RE: Request for Permit Modification
Municipal Solid Waste - Angelina County
Angelina County Waste Management Center- MSW Permit No. 2105A
CN600833511; RN101947323

**EXHIBIT 4.5
FINAL CONTOUR MAP
ANGELINA COUNTY
WASTE MANAGEMENT CENTER**

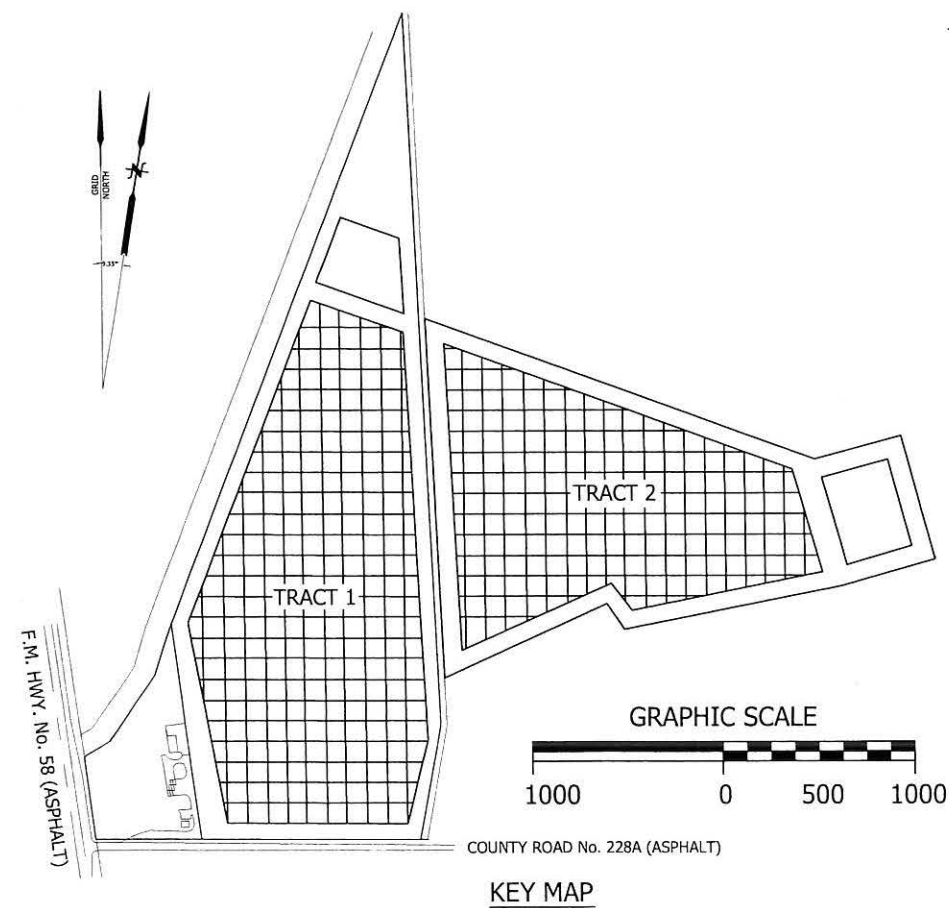
AREAS CLOSED WITH ALTERNATIVE FINAL COVER
WILL RECEIVE AN ADDITIONAL 18" OF SOIL
EROSION MATERIAL TO MEET PERMITTED FINAL
COVER GRADES.

NO.	DATE	DESCRIPTION	BY
1	07/15/13	LABEL HIGHEST CONTOUR 398.5'	CMP
1	05/06/13	REVISED CONTOURS TO ORIGINAL	CMP
